**VILLAGE OF LINCOLNWOOD  
PARKS & RECREATION DEPARTMENT**

**PUBLIC INPUT MEETING**

## ADA Assessment And Transition Plan

Developed by  
Sue Bear and Kelly Damron  
April 2011

Village of Lincolnwood Parks and Recreation Department  
Community Center - Village Hall

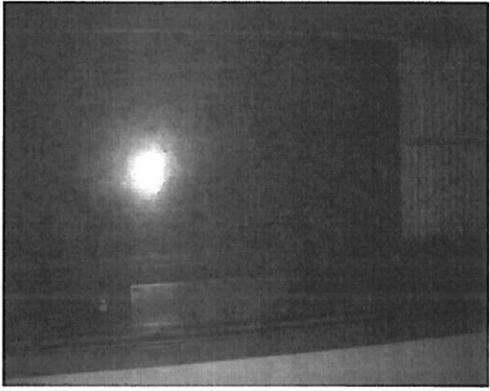
Photo	Barrier	ADAAG	Solution
	<p>Accessible Parking Locations are not Wide Enough.</p>	<p>502.2 Vehicle Spaces</p>	<p>Provide the proper width for each of your 4 accessible parking locations. They are currently 93 inches wide and are to be a minimum of 96 inches wide.</p>
<p>By Whom _____</p>	<p>Projected Cost _____</p>	<p>Projected Date _____</p>	<p>Action Taken _____</p>
<p>Point Person - _____</p>	<p>\$ _____</p>	<p>____/____/____</p>	<p>Specific Action taken _____</p>
<p><b>Additional Recommendations-</b> When you resurface your parking lot, we would suggest creating a minimum of 3 spaces for accessible parking that provide a minimum of 96 inches of parking width. If you are trying to provide a van space then the width would need to be a minimum of 132 inches for parking. You have a total of 45 parking spaces for the general public. You only need to have a minimum of 2 accessible parking spots at this location. Access Aisles also need to be marked and need to be a minimum of 60 inches wide.</p>

Village of Lincolnwood Parks and Recreation Department  
Administrative Offices - Village Hall

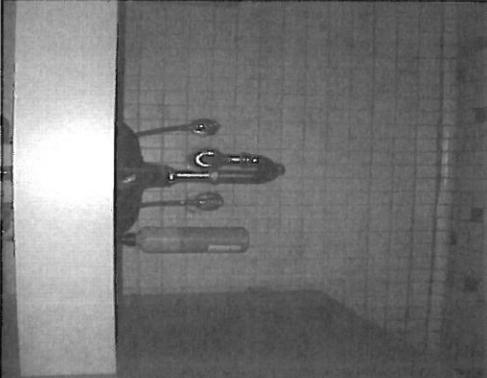
Photo	Barrier	ADAAG	Solution
	<p>Door Opening Pressure for Women's Restroom is too Heavy.</p>	<p>404.2.9 Door Opening Force</p>	<p>Decrease door opening pressure for women's restroom. The current door pressure is 10 lbs and must be a maximum of 5 lbs.</p>
By Whom	Projected Cost	Projected Date	Action Taken
Point Person - _____	\$ _____	_ / _ / _	Specific Action taken
Additional Recommendations-

Village of Lincolnwood Parks and Recreation Department  
Administrative Offices - Village Hall

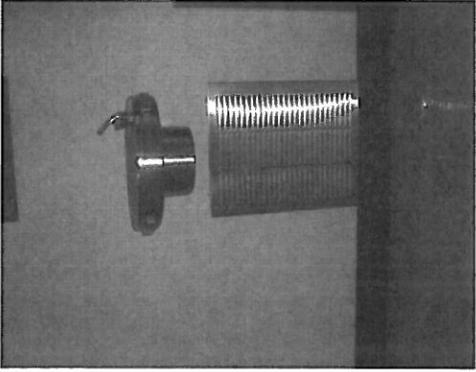
Photo	Barrier	ADAAG	Solution
	<p>Door Opening Pressure for Men's Restroom is too Heavy.</p>	<p>404.2.9 Door Opening Force</p>	<p>Decrease door opening pressure for Men's restroom. The current door pressure is 10 lbs and must be a maximum of 5 lbs.</p>
<p>By Whom _____</p>	<p>Projected Cost _____</p>	<p>Projected Date _____</p>	<p>Action Taken</p>
<p>Point Person - _____</p>	<p>\$ _____</p>	<p>____/____/____</p>	<p>Specific Action taken</p>
<p>Additional Recommendations-</p>

Village of Lincolnwood Parks and Recreation Department  
Proesel Pool

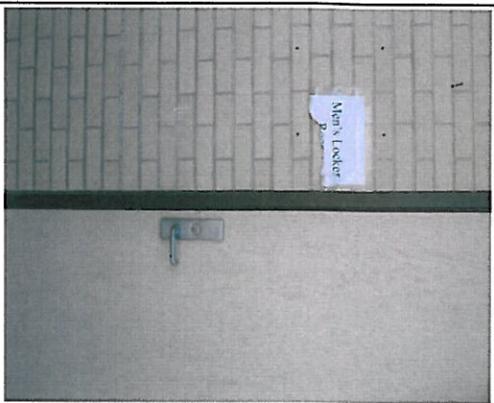
Photo	Barrier	ADAAG	Solution
	<p>Door Opening Pressure for Women's Locker Room is too Heavy.</p>	<p>404.2.9 Door Opening Force</p>	<p>Decrease door opening pressure for Women's Locker Room. The current door pressure is 10 lbs and must be a maximum of 5 lbs.</p>
<p>By Whom _____</p>	<p>Projected Cost \$ _____</p>	<p>Projected Date ____/____/____</p>	<p>Action Taken  Specific Action taken</p>
<p>Additional Recommendations-</p>

Village of Lincolnwood Parks and Recreation Department  
Proesel Pool

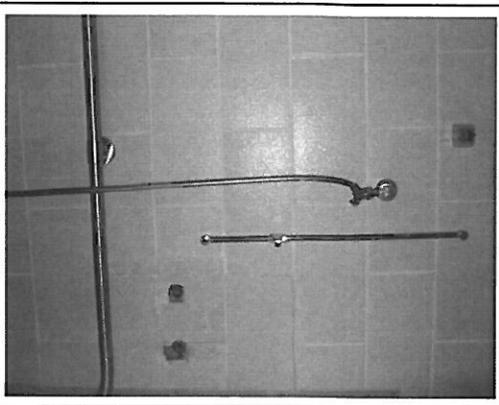
Photo	Barrier	ADAAG	Solution
	<p>Shower Control Height in Women's Locker Room is to high.</p>	<p>608.5.2 Standard Roll in-In Type Shower Compartments</p>	<p>Move the current location of the slide bar to hold the shower controls to a maximum of 48 inches above the finish of the floor.</p>
<p>By Whom</p>	<p>Projected Cost</p>	<p>Projected Date</p>	<p>Action Taken</p>
<p>Point Person - _____</p>	<p>\$ _____</p>	<p>____/____/____</p>	<p>Specific Action taken</p>
<p>Additional Recommendations-</p>

**Village of Lincolnwood Parks and Recreation Department  
Administrative Offices - Village Hall**

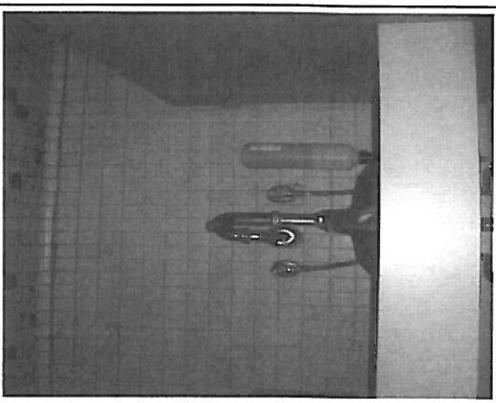
Photo	Barrier	ADAAG	Solution
	Door Opening Pressure for Men's Restroom is too Heavy.	404.2.9 Door Opening Force	Decrease door opening pressure for Men's restroom. The current door pressure is 10 lbs and must be a maximum of 5 lbs.
By Whom _____  Point Person - _____	Projected Cost \$ _____	Projected Date ___/___/___	Action Taken  Specific Action taken

Village of Lincolnwood Parks and Recreation Department  
 Administrative Offices - Village Hall

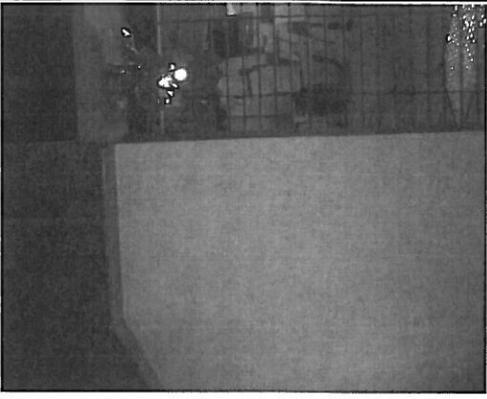
Photo	Barrier	ADAAG	Solution
	<p>Drinking Fountain Spout location is to high for individual using a wheelchair.</p>	<p>602.4 Spout Height</p>	<p>- Provide a drinking fountain spout a maximum of 36 inches from the floor. The current spout height is 42 inches.</p>
<p>By Whom</p>	<p>Projected Cost</p>	<p>Projected Date</p>	<p>Action Taken</p>
<p>Point Person - _____</p>	<p>\$ _____</p>	<p>___/___/___</p>	<p>Specific Action taken</p>
<p>Additional Recommendations-</p>

Tennis Court Access Protrusion (Northeast Side)

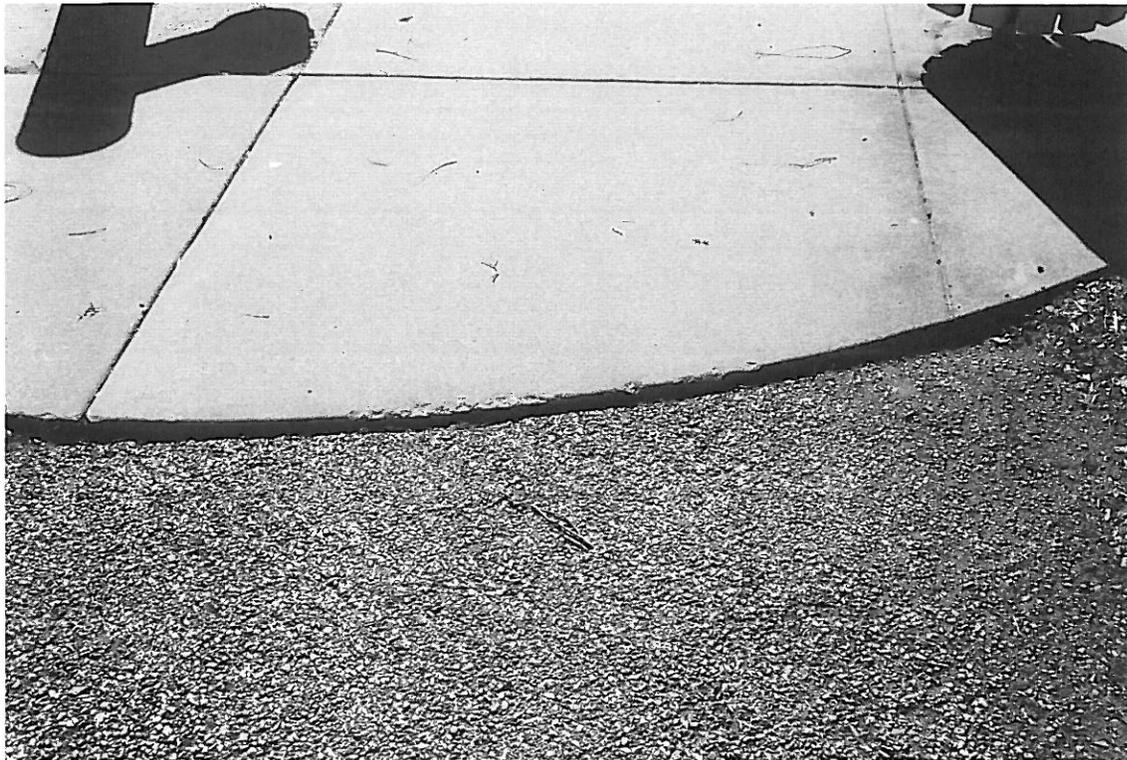
- \* Tennis court only has one entrance accessible
- \* Asphalt paths are in rough condition w/ many protrusions making it tough for wheel chair accessibility
- \* Benches need arm rests

Village of Lincolnwood Parks and Recreation Department -  
Proesel Park

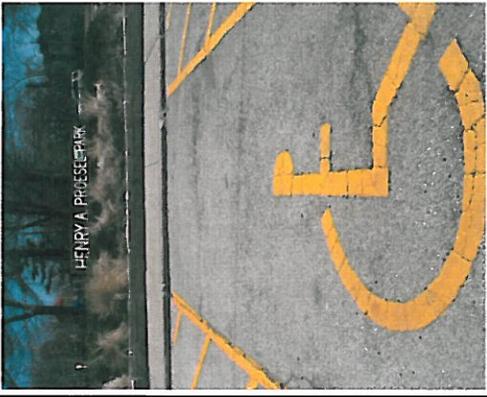
Photo	Barrier	ADAAG	Solution
	<p>Concrete and surface at entrance to playground not even with playground surfacing.</p>	<p>Trip Hazard</p>	<p>- Build up current surfacing in order to provide an accessible route which is flat to allow safe travel of wheelchair and pedestrian travel.</p>
<p>By Whom</p>	<p>Projected Cost</p>	<p>Projected Date</p>	<p>Action Taken</p>
<p>Point Person - _____</p>	<p>\$ _____</p>	<p>___/___/___</p>	<p>Specific Action taken</p>
<p><b>Additional Recommendations-</b> We would suggest making the surface at entrance even in order to prevent a trip hazard.</p>

Village of Lincolnwood Parks and Recreation Department -  
Central Park

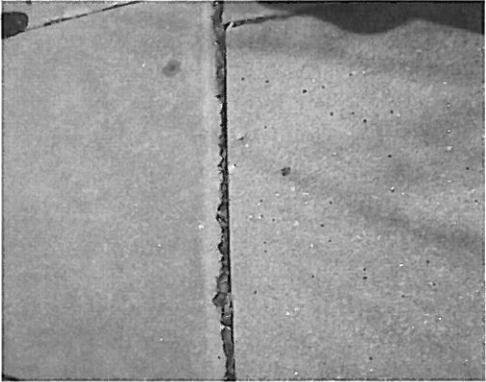
Photo	Barrier	ADAAG	Solution
	<p>Central Park benches do not have transfer arm rests. 30% of benches must be accessible.</p>	<p>902.4.1 Clear floor and ground space</p>	<p>Install a minimum of one set of armrests at this location to allow transfer from wheelchair to bench.</p>
<p>By Whom</p>	<p>Projected Cost</p>	<p>Projected Date</p>	<p>Action Taken</p>
<p>Point Person - _____</p>	<p>\$ _____</p>	<p>___/___/___</p>	<p>Specific Action taken</p>
<p><b>Additional Recommendations-</b></p>

Village of Lincolnwood Parks and Recreation Department -  
Central Park

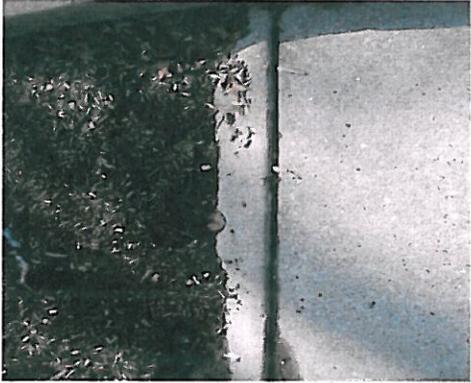
Photo	Barrier	ADAAG	Solution
	<p>Picnic Table is not accessible. No clear floor or ground space. No wheelchair accessible location.</p>	<p>902.4.1 Clear floor and ground space</p>	<p>- Remove one of the current benches in order to provide a minimum of 1/3 seating with an accessible seating area. The accessible location needs to have wheelchair access with specified clear width.</p>
<p>By Whom _____</p>	<p>Projected Cost _____</p>	<p>Projected Date _____</p>	<p>Action Taken</p>
<p>Point Person - _____</p>	<p>\$ _____</p>	<p>____/____/____</p>	<p>Specific Action taken</p>
<p><b>Additional Recommendations-</b></p>

Village of Lincolnwood Parks and Recreation Department -  
Central Park

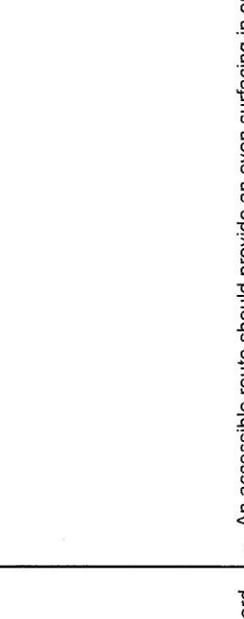
Photo	Barrier	ADAAG	Solution
	<p>Concrete at bottom of ramp entrance to playground is not even with playground surfacing.</p>	<p>Trip Hazard</p>	<p>- Build up current surfacing in order to provide an accessible route which is flat to allow safe travel of wheelchair and pedestrian travel.</p>
<p>By Whom</p>	<p>Projected Cost</p>	<p>Projected Date</p>	<p>Action Taken</p>
<p>Point Person - _____</p>	<p>\$ _____</p>	<p>____/____/____</p>	<p>Specific Action taken</p>
<p><b>Additional Recommendations-</b> We would suggest adding more surfacing to make the surface at entrance of ramp even in order to prevent a trip hazard.</p>
